Final SR 60 and Combined Alternatives Issues and Constraints Report

GOLD LINE EASTSIDE TRANSIT CORRIDOR PHASE 2

January 2020

Figure 3-1. Draft SR 60 Alternative Alignment Shift—ROW Footprint Via Campo at Findlay

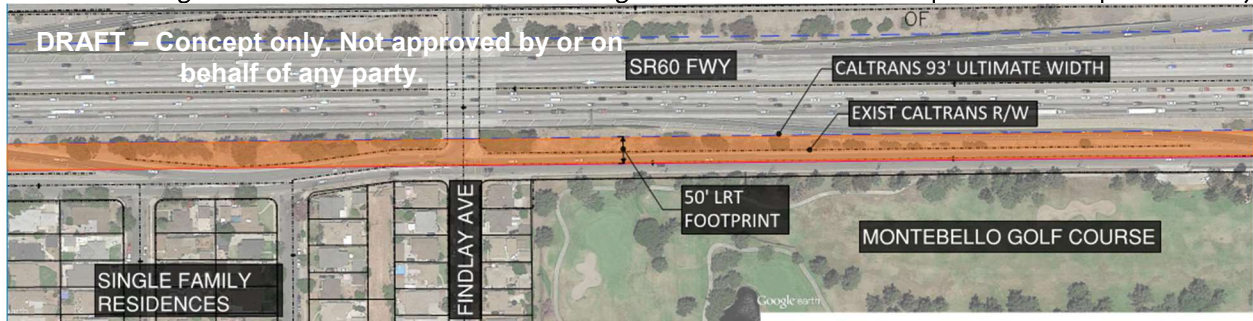
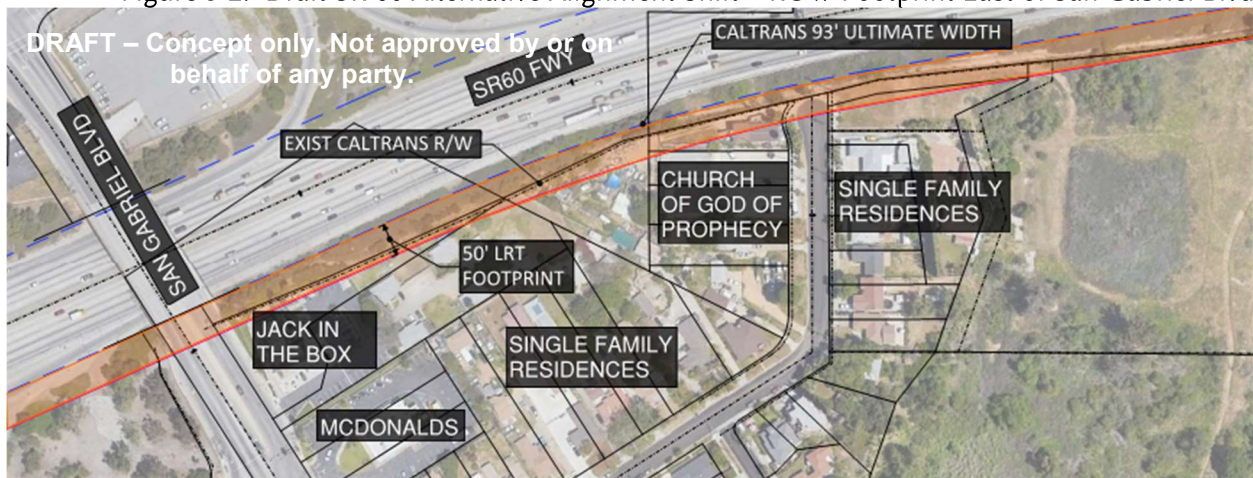
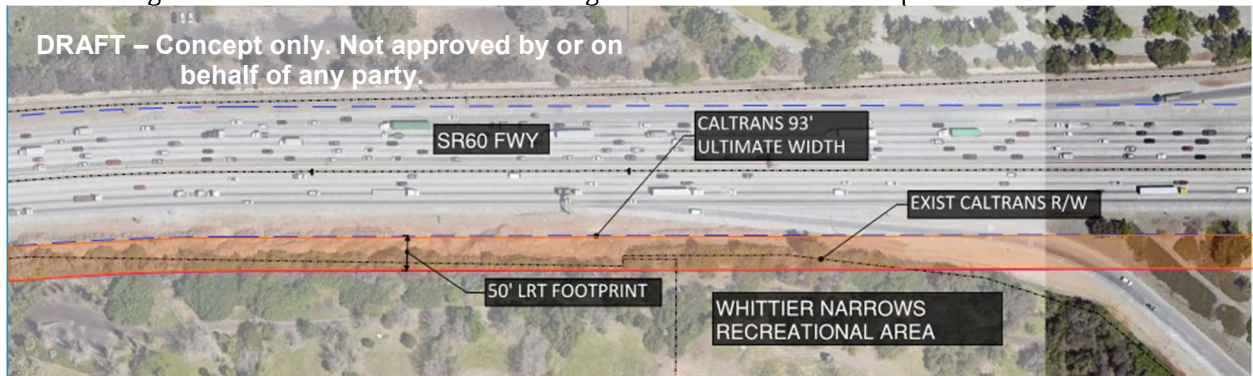
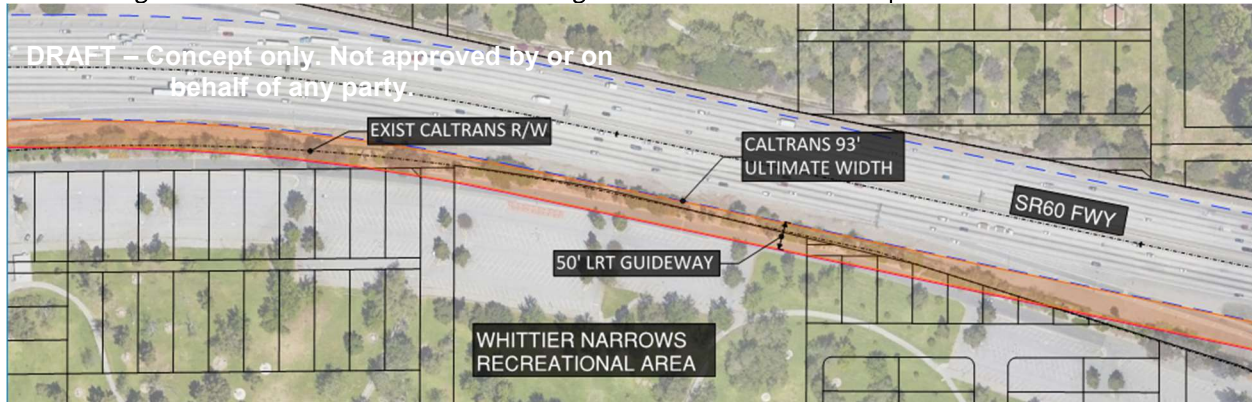
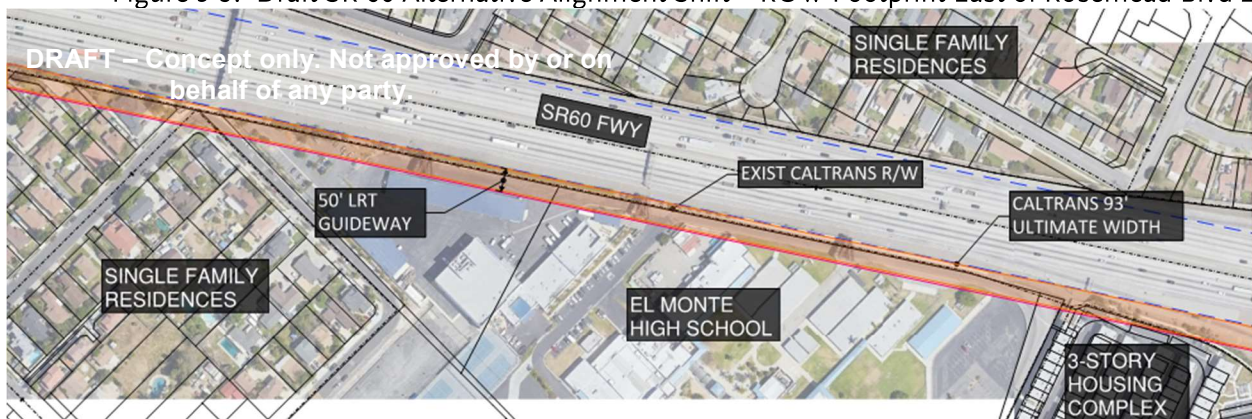
In subsequent meetings that took place in 2019, Caltrans underscored that the SR 60 Alternative will impact Caltrans’ ability for future widening which would bring existing general-purpose lanes up to Caltrans current standards and add High-Occupancy-Vehicle lanes. Caltrans’ future plan for the SR 60 Freeway would result in shifting the SR 60 Alternative aerial guideway out of the Caltrans ROW. Based on Caltrans planned criteria for the freeway, an approximate 93-foot buffer was agreed upon as sufficient ROW to accommodate future improvements. The 93-foot buffer is conceptual and would require Caltrans approval upon submittal of the Advanced Conceptual Engineering drawings.

The guideway shift that would be required for Caltrans’ future expansion is delineated by the orange footprint shown on Figure 3-1 through Figure 3-5. The alignment shift below is conceptual and would require Caltrans coordination and approval. As shown, the SR 60 Alternative alignment shift would further impact adjacent roadways, residential areas, community facilities, and other environmentally-protected resources such as the Whittier Narrows Recreational Area.

Figure 3-6. Peck Road Station Placement

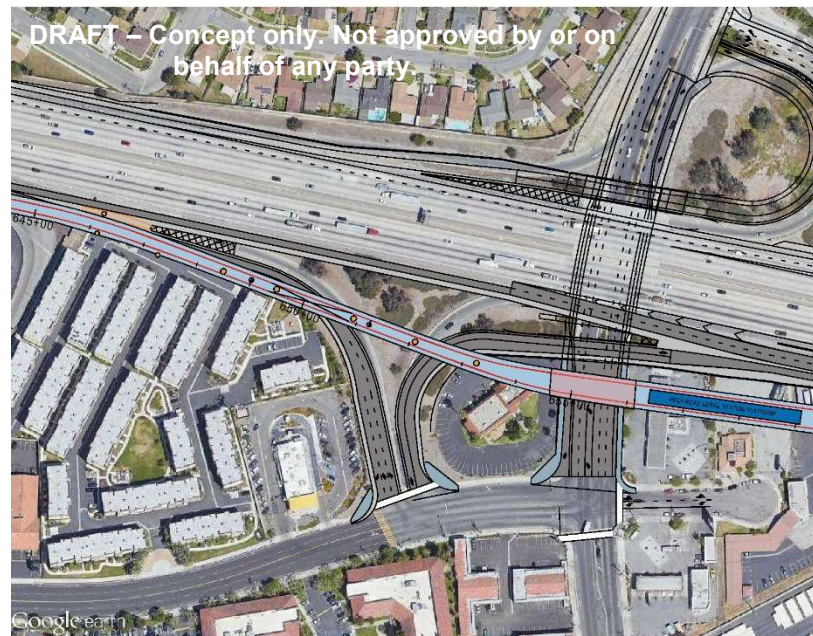
Since 2014, the Project design efforts have incorporated the planned SR 60/I-605 Interchange improvements to minimize impacts to the immediate area. A portion of the current design of the LRT guideway shares a common project footprint with the Peck Road off-ramp improvements (displayed in Figure 3-6 below). This proposed design of the LRT guideway would be subject to Caltrans approval and places the guideway within approximately 5 feet of the residential condominiums adjacent to the freeway ramp. The Encroachment Permit process required by Caltrans, typically does not allow for projects to extend laterally within their facilities and may require redesign of the guideway. Should Caltrans not approve the design, the guideway would need to provide clearance for the off-ramps placing the guideway farther south, heightening the impacts to the condominiums.

- Potential acquisition or impacts to 117 condominium units, west of the interchange to provide the ROW that Caltrans' requires. In order to accommodate the future widening of the freeway and realigned Peck Road off-ramp, the LRT guideway was shifted further to the south near the condominium units. The proposed design may not be approved by Caltrans resulting in further real estate impacts and acquisitions.
- SCE high-voltage transmission lines do not meet minimum vertical clearances from the track extension to the SR 60 MSF and would have to be raised approximately 50 feet, which would increase cost;

Figure 4-2. Oil Superfund Site (Landfill)

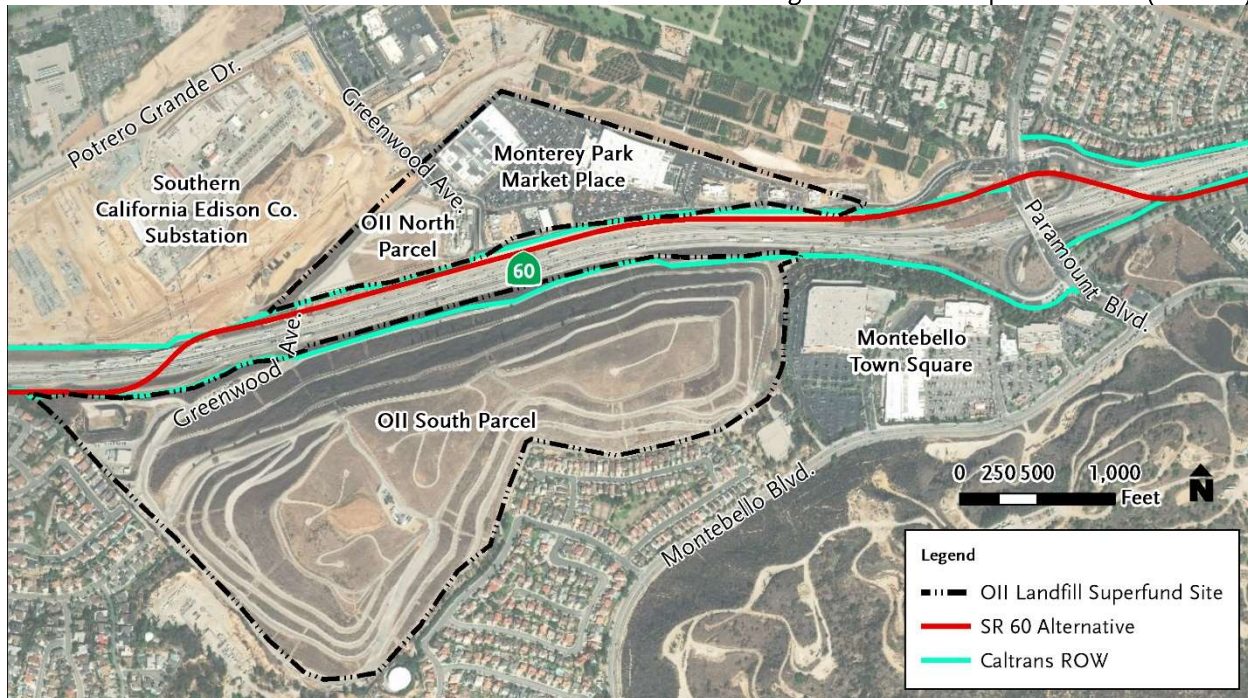
Since the 2014 Draft EIS/EIR and 2017 Post Draft EIS/EIR Technical Study, additional focused technical analyses have taken place to further study this area. In order to avoid the OII Superfund site, the SR 60 Alternative would need to transition approximately 1.5 miles of the guideway from the south side of the SR 60 Freeway to the north side. It is expected that the SR 60 Alternative guideway would be constructed mostly within the Caltrans SR 60 ROW on the north side but may straddle the OII North Parcel boundary line. In 1991, the EPA issued a consent decree for remedial activities that improved the condition of the North Parcel along the planned SR 60 Alternative alignment. The activities included the removal of landfill waste and aurally deposited lead (ADL) within an approximate 73-foot wide corridor parallel to the northern edge of SR 60 Freeway, which falls primarily within the Caltrans ROW. In addition, a “monocover” was constructed to cover the North Parcel. The EPA has commented on their concerns about potential impacts and constructability and safety challenges of the SR 60 Alternative on or near the OII Superfund Site, including landfill gas pathways, air leakage leading to underground fires, and potential to disturb landfill waste.
